## ■ Band voltage modification

If you want to connect an external unit which can be controlled by the band voltage from [ACC] connector, the modification is necessary as at right.

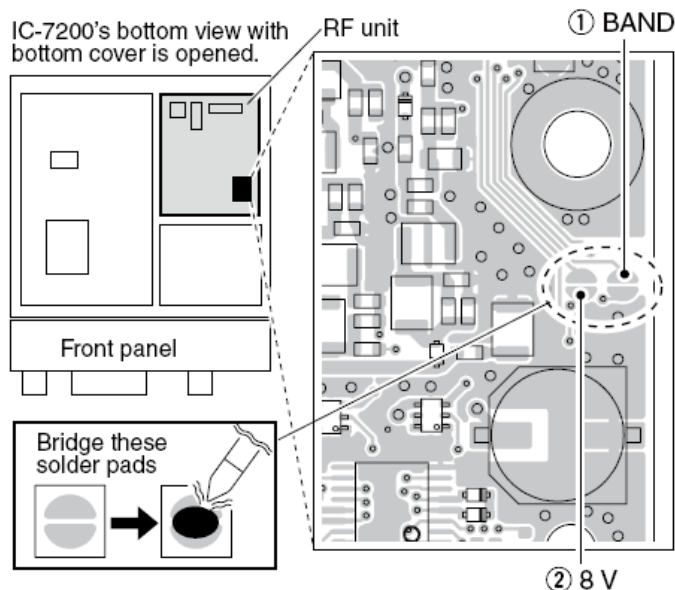
The band voltage appears from pin 5 of [ACC] connector after modification (①) is completed, or the regulated 8 V appears from pin 1 of [ACC] connector after modification (②) is completed.

### • Band voltage generator circuit

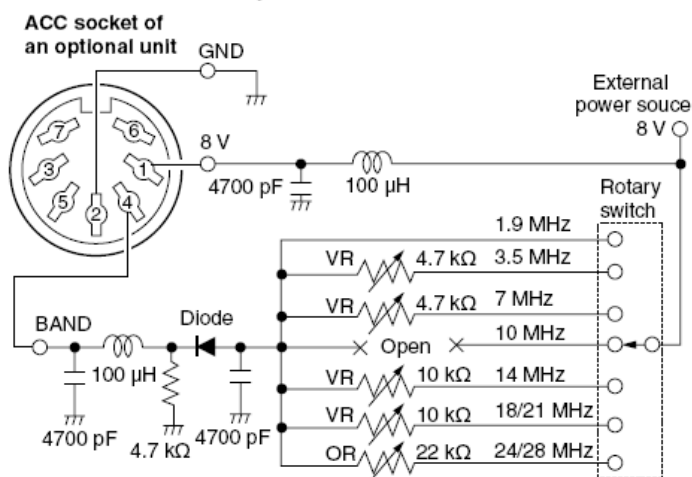
The below circuit is just for reference.

The following band voltage table is for reference only. Please adjust and confirm against the actual operating condition.
